**Vogtle Electric Generating Plant  
Response to NRC Questions Regarding  
Request to Revise Technical Specifications and  
Pressure and Temperature Limits Report**

**SNC Response to NRC Questions Regarding  
Vogtle Electric Generating Plant Units 1 and 2  
Technical Specification Revision and PTLR Submittal**

**Pressure-Temperature (P-T) limits (TAC Nos. MC2225 and MC2226)**

Figure 1: Graphical Representation of the Data Comparison from Table 1

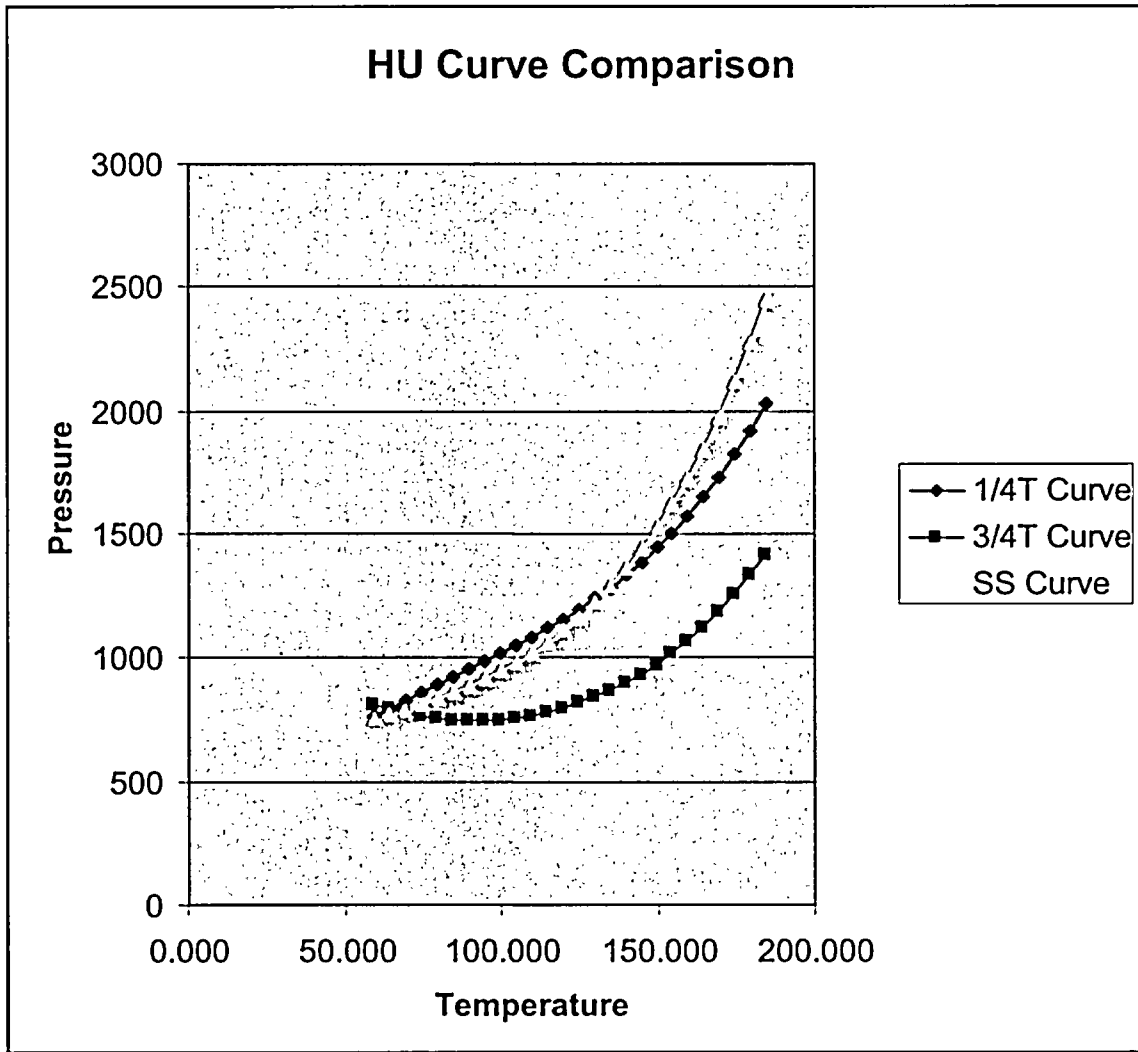
Figure 5-1 (for 26 EFPY) of WCAP-15068, Revision 3, "Vogtle Electric Generating Plant Unit 1 Heatup and Cooldown Limit Curves for Normal Operation," shows that the heatup curve for 100°F/hr maintains a constant pressure of 748 psig from 60°F to 90°F; instead of a smooth, pressure varying P-T limit curve derived directly from the American Society of Mechanical Engineers (ASME) Code, Section XI, Appendix G methodology as described in Section 3 of this WCAP. Provide the basis and detailed calculations for this part of the P-T limit curve. A similar concern applies to Figure 5-3 (for 36 EFPY) of WCAP-15068, Revision 3 and Figure 5-1 (for 26 EFPY) and Figure 5-3 (for 36 EFPY) of WCAP-15161, Revision 3, "Vogtle Electric Generating Plant Unit 2 Heatup and Cooldown Limit Curves for Normal Operation." No justification is required for these P-T limit curves if it is the same as that for Figure 5-1 of WCAP-15068, Revision 3. However, if this concern results in a revision of the proposed P-T limits, all four figures mentioned above should be revised.

Table 1 below shows the actual pressure data for the 1/4T, 3/4T and Steady State PT Curves generated by Westinghouse for the Vogtle Unit 1 26 EFPY PT curves (100°F/hr and Steady State). Figure 1 is a graphical representation of that data. The Westinghouse computer program compares the pressure from each column and takes the minimum data point at each given temperature. Additionally, if the curve drops to a minimum pressure point after Temp = 60°F, then the preceding pressures are also set to that minimum pressure point. As can be seen below, the minimum pressure from 60°F to 95°F is 748 psig. Therefore the curve is conservatively set to this minimum pressure point from Temp = 60°F to 95°F. This occurs similarly for all of the Vogtle Unit 1 and Unit 2 PT Curves.
